# FINDINGS AND RECOMMENDATION OFFICE OF PLANNING AND ZONING ANNE ARUNDEL COUNTY, MARYLAND

CASE NUMBER: 2024-0101-V COUNCILMANIC DISTRICT: 5

### **REQUEST**

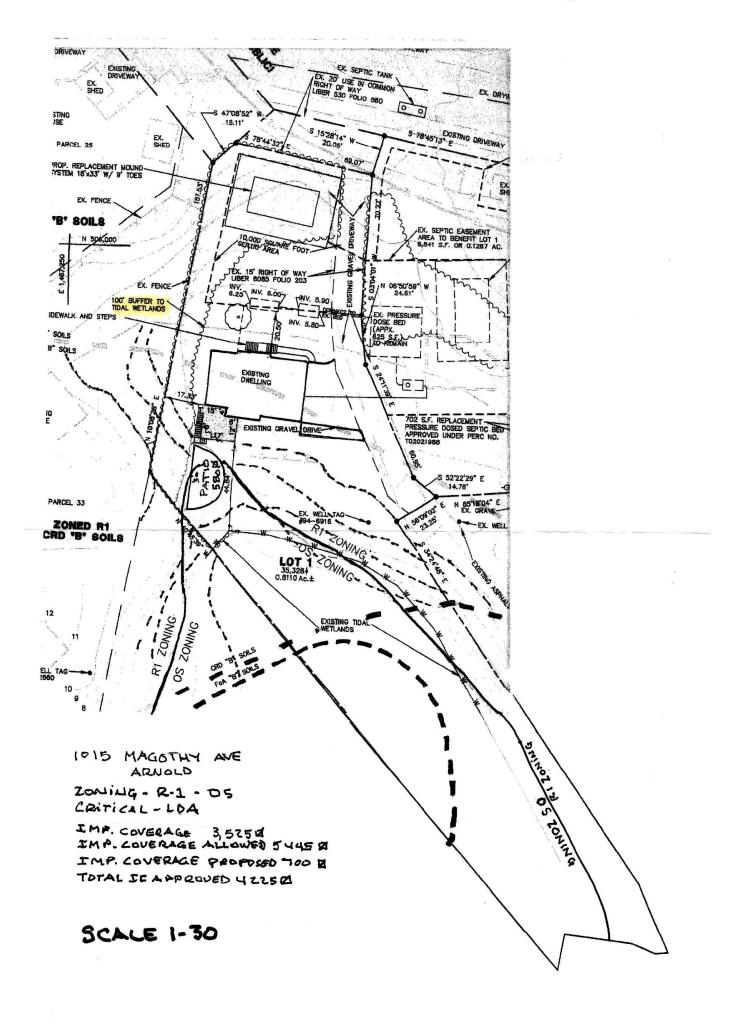
result of actions by the applicants, as they constructed the patio, retaining wall, and fireplace without the proper permit and variance approvals. The variance does not appear to arise from any condition relating to land or building use on any neighboring property. While the applicants note an erosive condition, they should have contacted the County to make a determination as to whether a retaining wall was necessary to cure the condition and, if so, what the appropriate remedy would be. Retaining walls deemed necessary prior to construction do not require a variance. Either way, a patio and fireplace are most certainly not necessary to cure an erosive condition. The granting of the variance would adversely affect water quality or impact fish, wildlife, or plant habitat and would not be in harmony with the general spirit and intent of the County's Critical Area Program. The applicants have not overcome the presumption that the specific development does not conform to the general purpose and intent of the Critical Area law nor have they evaluated or implemented site plan alternatives.
